Site Instruction

SI 24

PROJECT : Hampton Manor
PROJECT No : 1136.13
DATE : August 14, 2018

Title: Removal of Insulation behind Precast

WALL SECTION 1 CONTINUED
SCALE - 1/8" = 1'-0"
1
A602

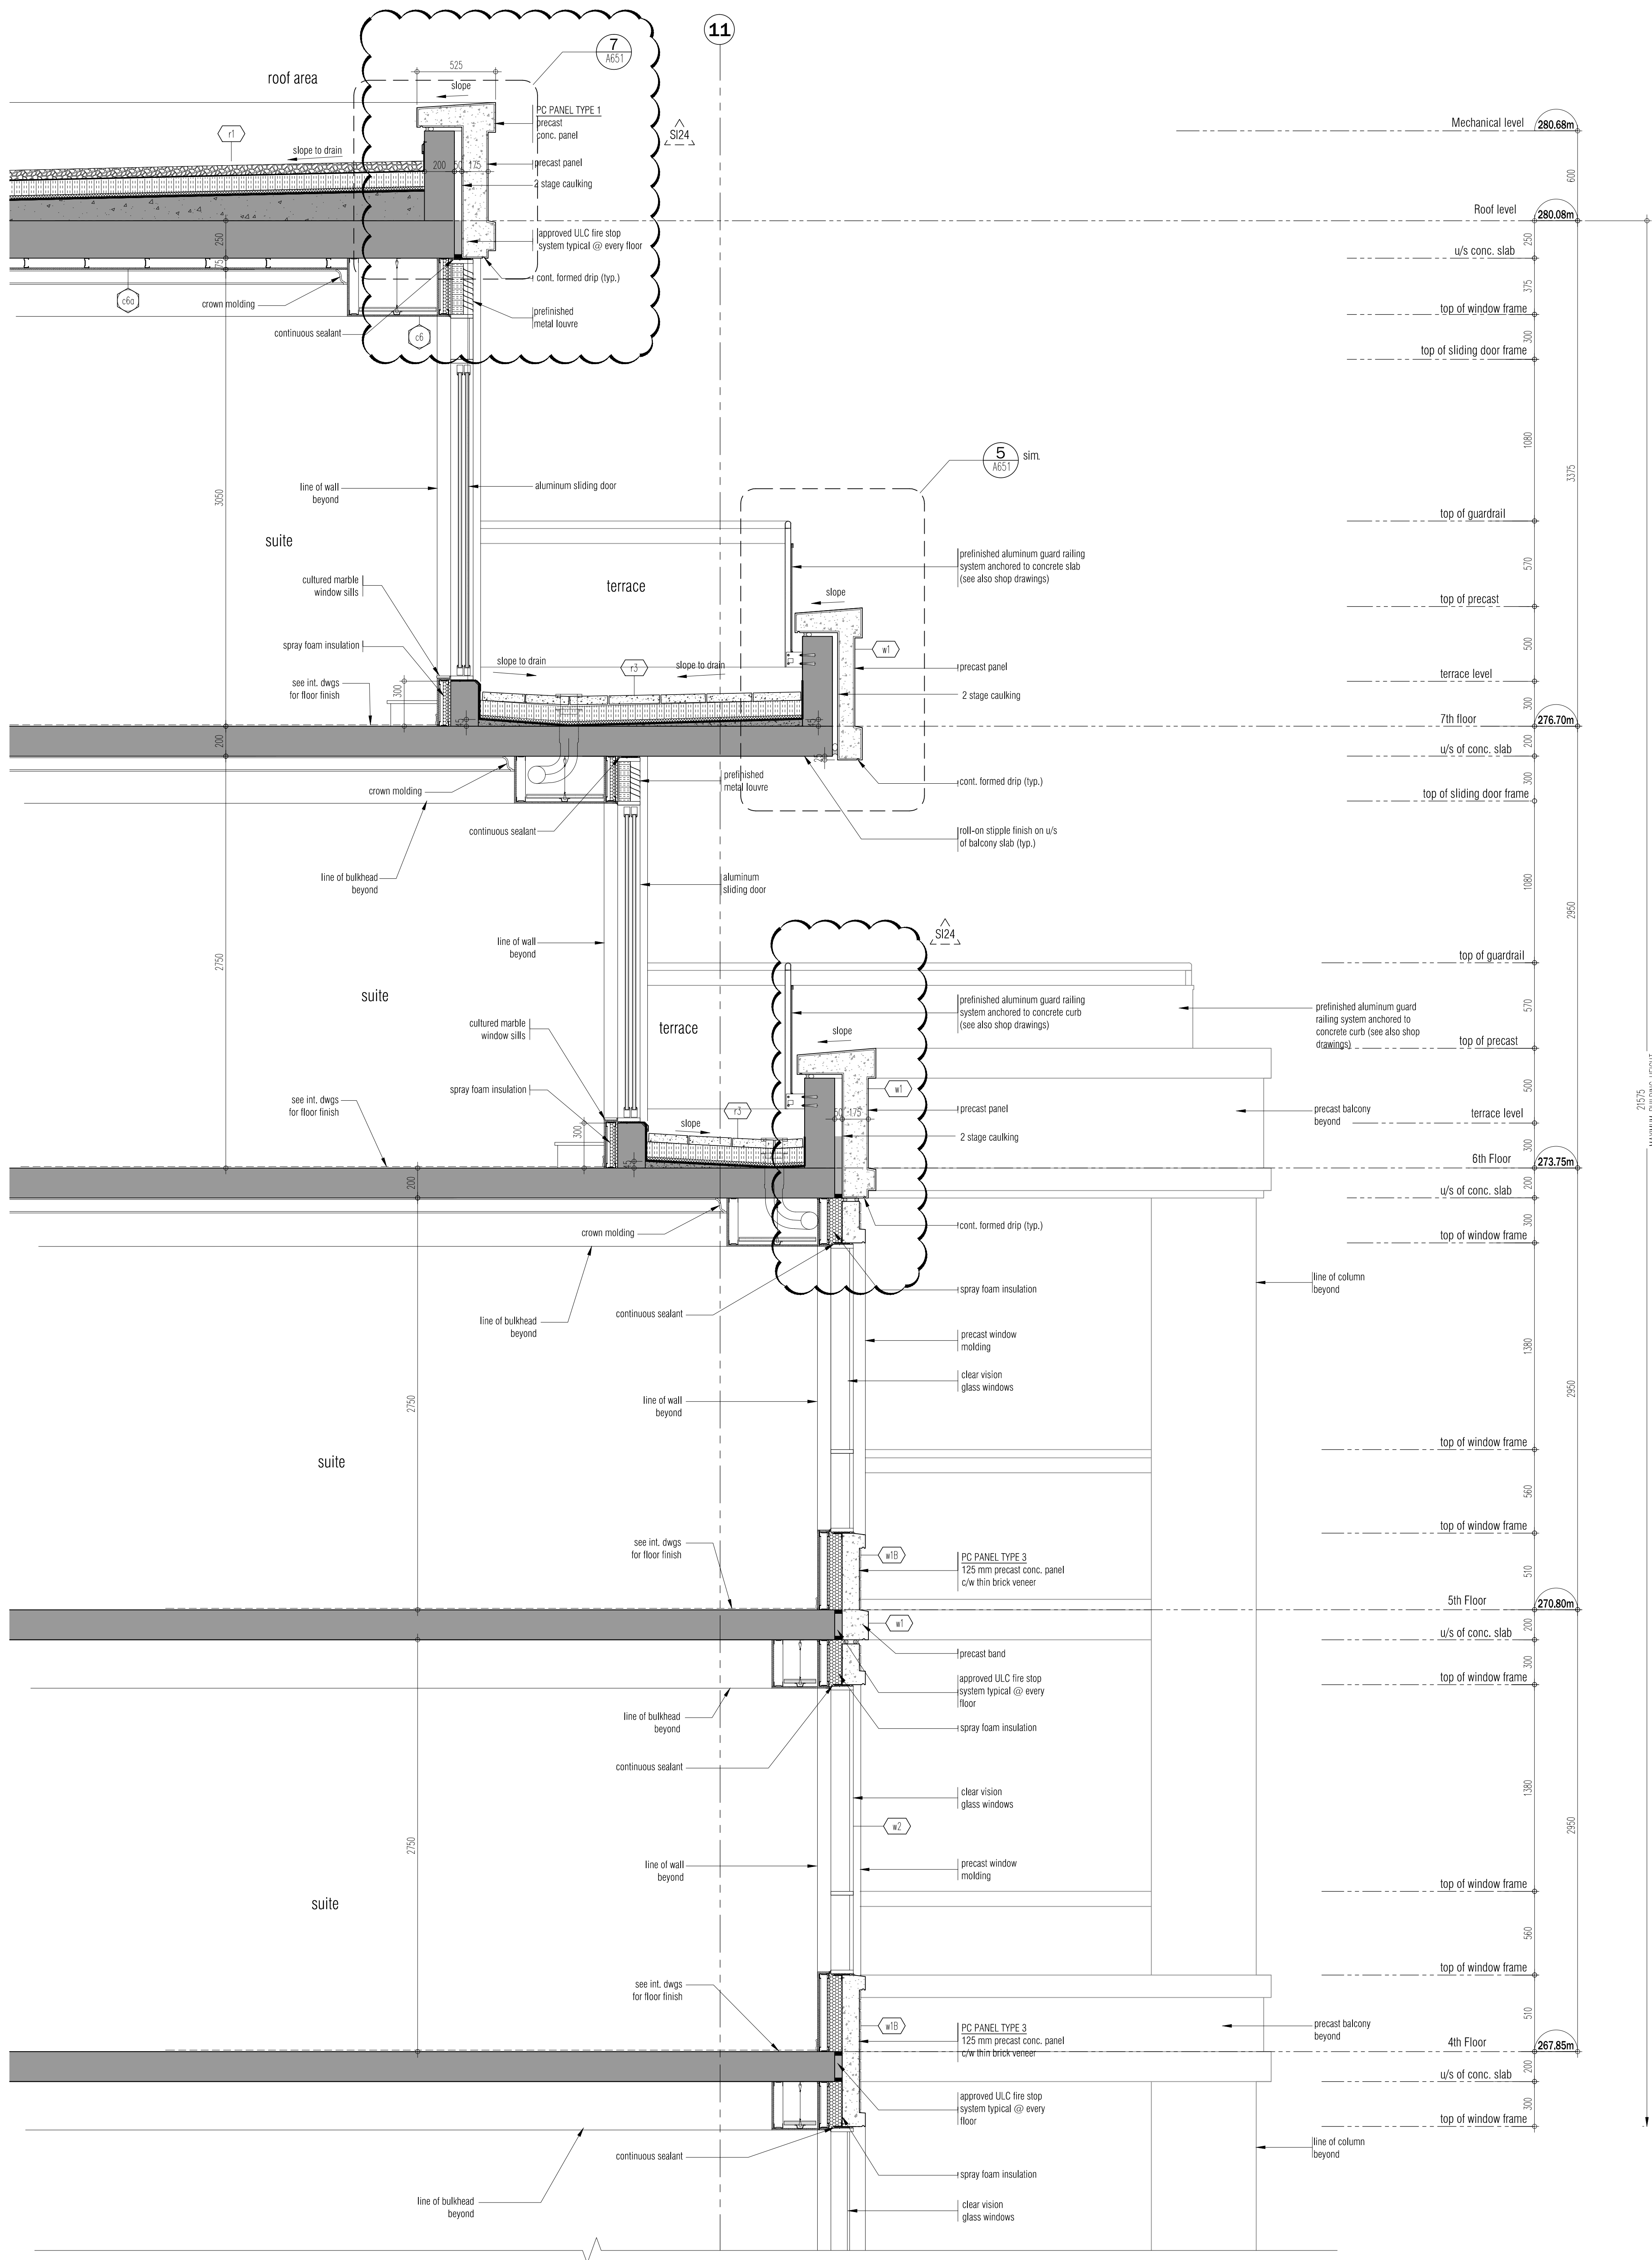
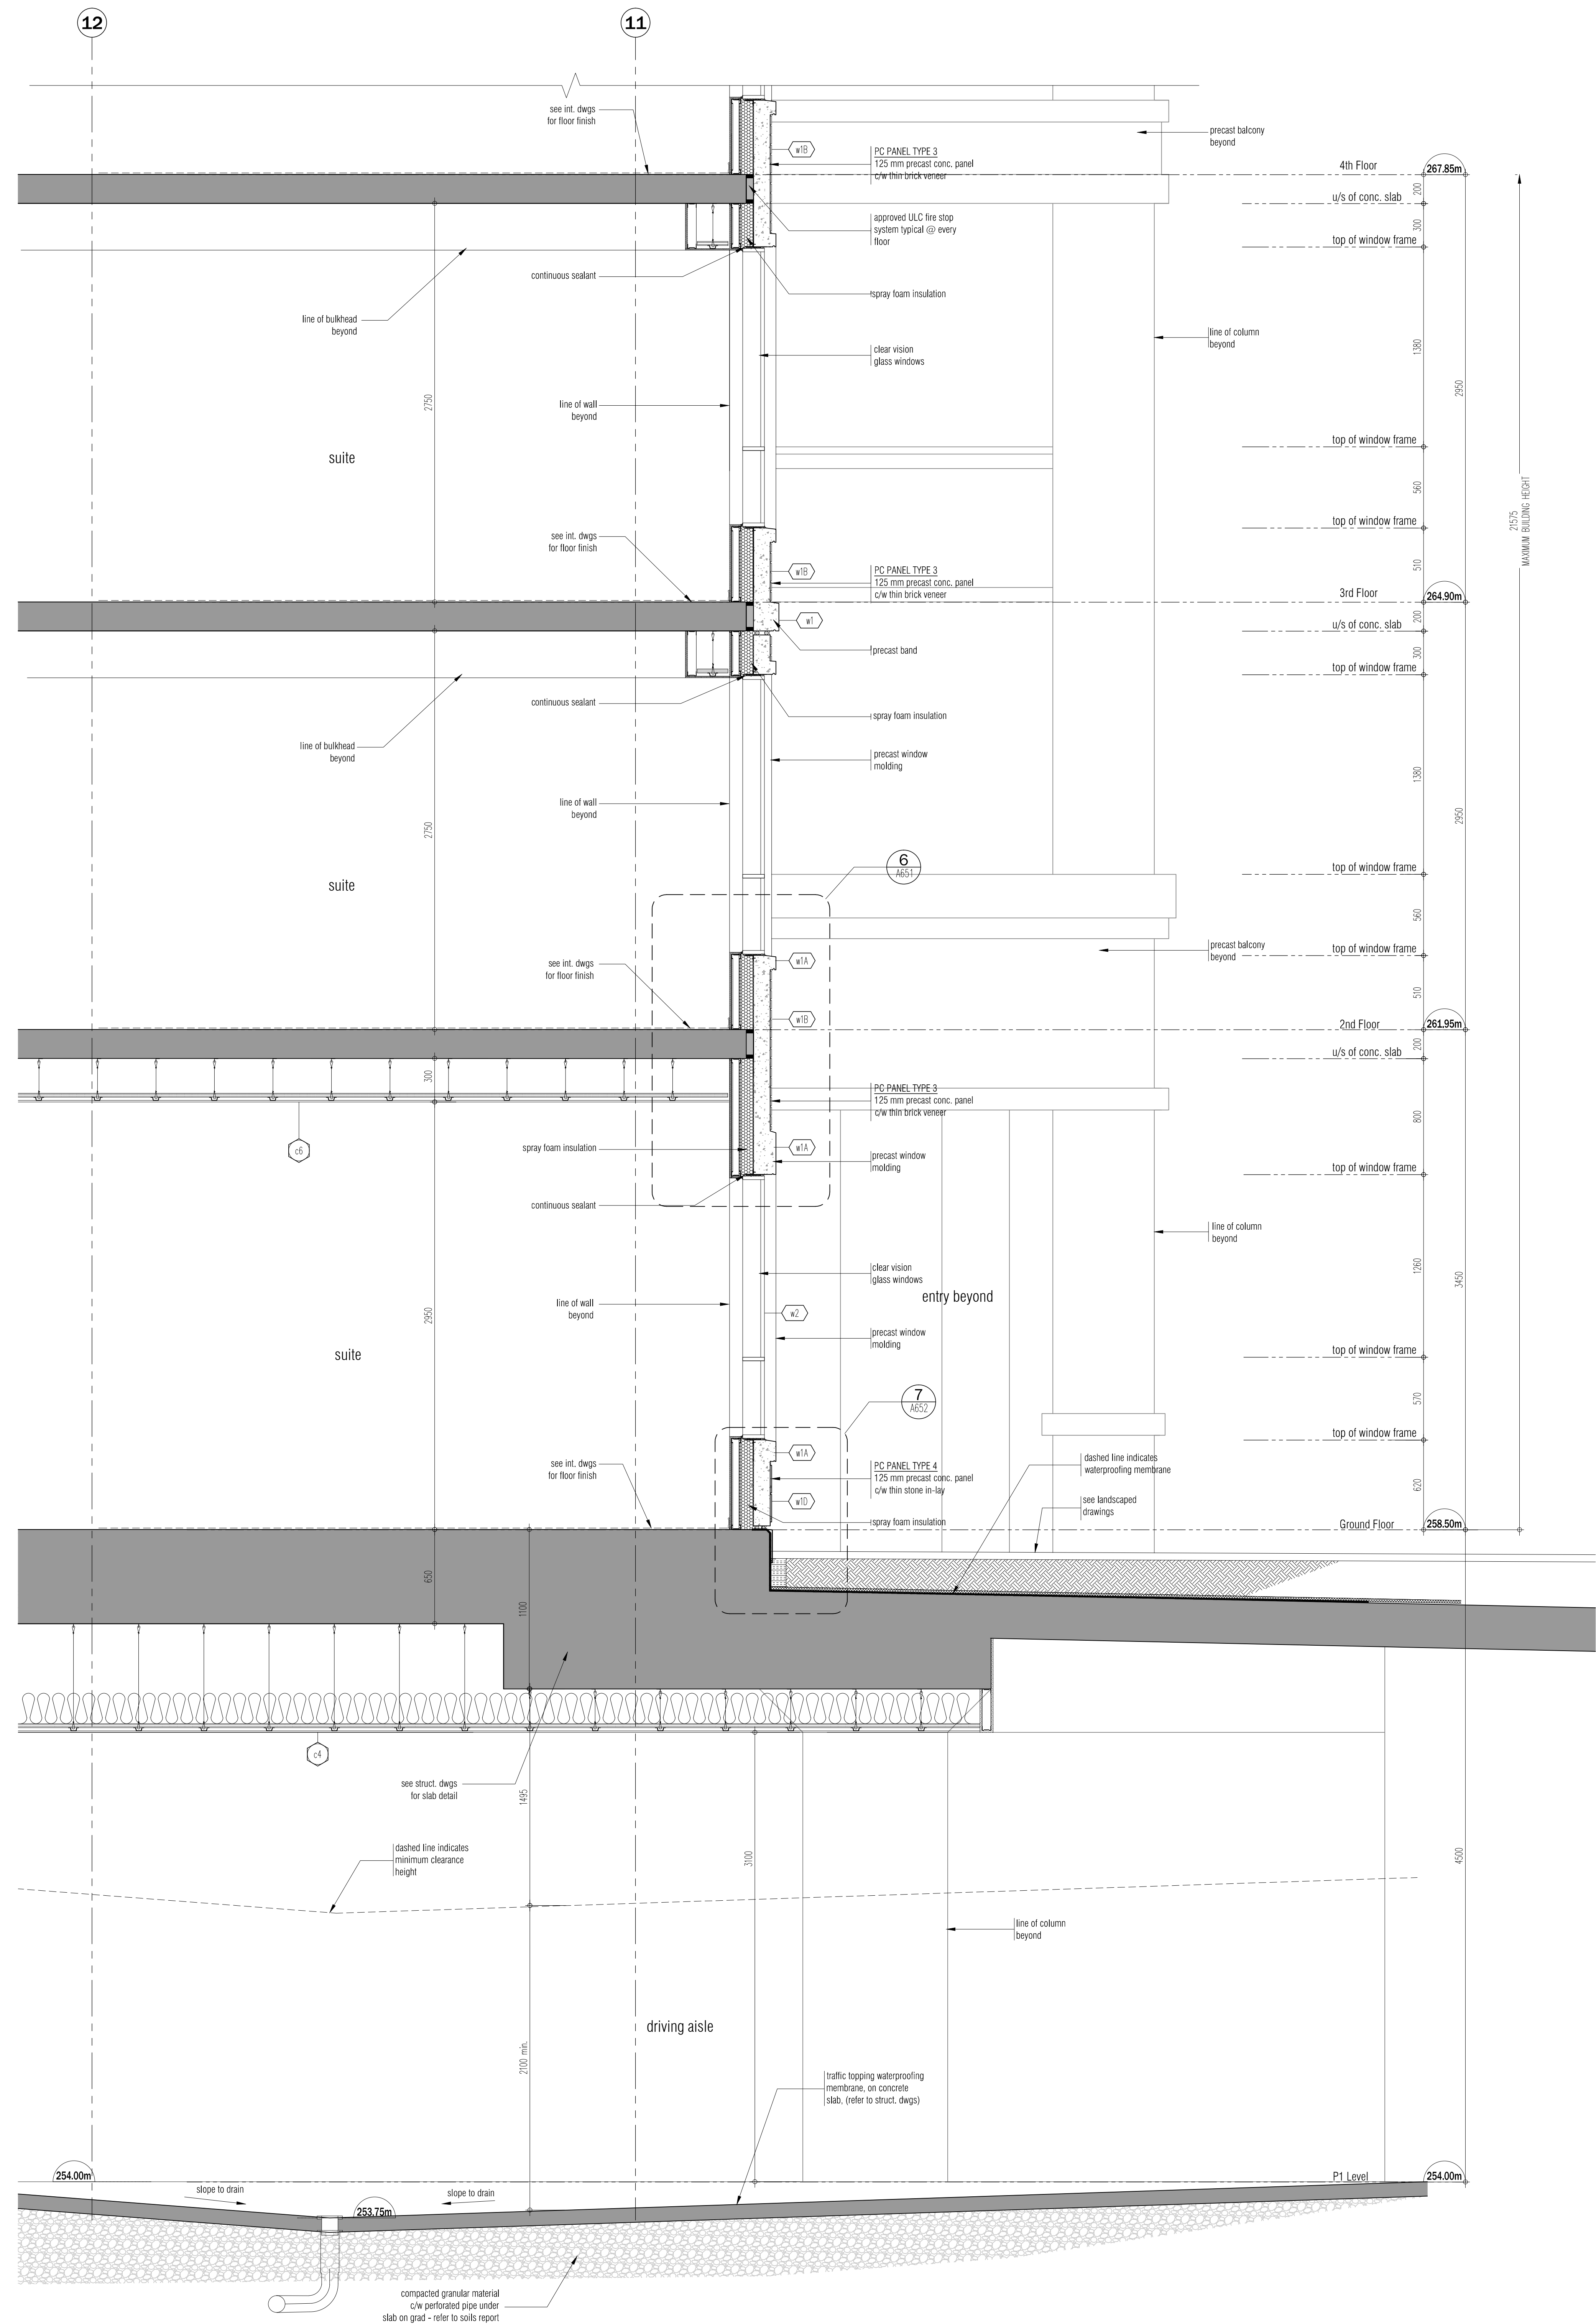
- Removal of insulation behind precast at terraces and roof.
